NHTSA Safety Recall  
No. 13V-458

## IMPORTANT SAFETY RECALL

# Customer Service Notice

## Pressure Switch and Exhaust Thermal Blanket Inspection

**Figure 1 — Thermal Blanket**

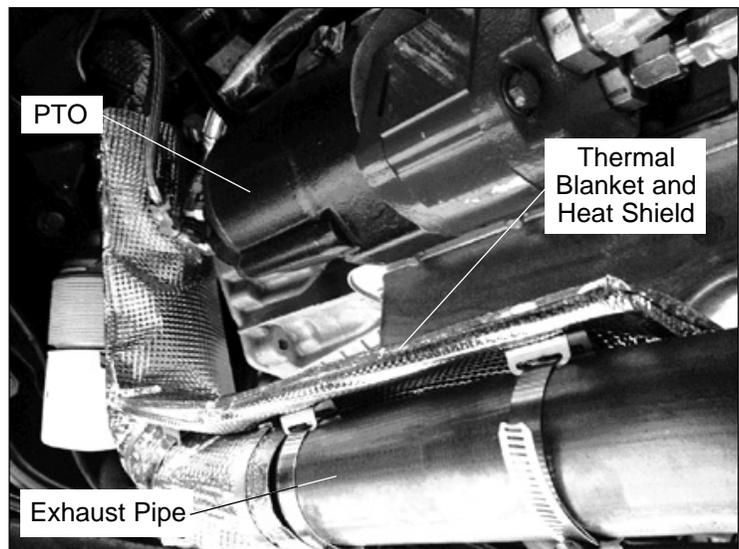
Altec has been made aware of a possible issue concerning a pressure switch and exhaust thermal blanket (refer to Figure 1) provided by the supplier of the power take off (PTO). Over time, the pressure switch can develop a low volume transmission fluid leak and the exhaust thermal blanket can deteriorate causing it to absorb hydraulic oil or transmission fluid. A buildup of oil or transmission fluid on the thermal blanket may increase the possibility of a fire. **Death or serious injury can result from a chassis fire.**

If the exhaust thermal blanket fails the inspection and/or there is evidence of a pressure switch leak, remove the exhaust thermal blanket at the time of the inspection and install the Pressure Switch and Exhaust Heat Shield Kit, part number 970510446, within 30 days of removal of the exhaust thermal blanket. Pressure switches and exhaust thermal blankets that pass the inspection must still have the Pressure Switch and Exhaust Heat Shield Kit installed at the next service interval.

**Figure 1 — Front Pressure Switch Location**

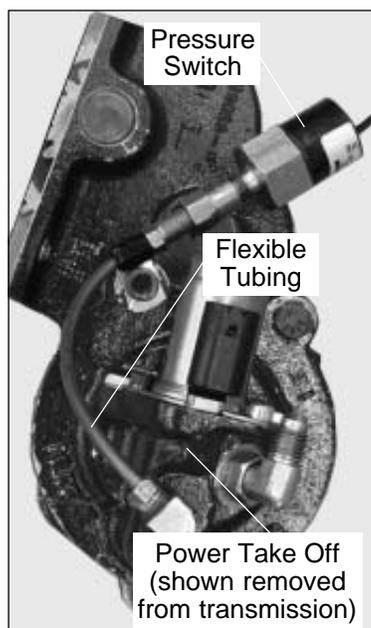
1. Position the unit on a level surface, apply the parking brake and chock the wheels. Shut off the engine and allow the chassis exhaust system to cool to the touch.
2. Using a mechanic's creeper, get under the chassis near the PTO on the driver's side of the transmission.
3. Find the thermal blanket that is attached with band clamps to the exhaust system near the PTO.
4. Use your hand to determine if the thermal blanket is wet with fluid. Look at the pressure switch to see if it is leaking transmission fluid. The pressure switch is located either on the front side of the PTO connected to a flexible tube (refer to Figure 1), or on the side near the rear of the PTO connected to a formed tube (refer to Figure 2).
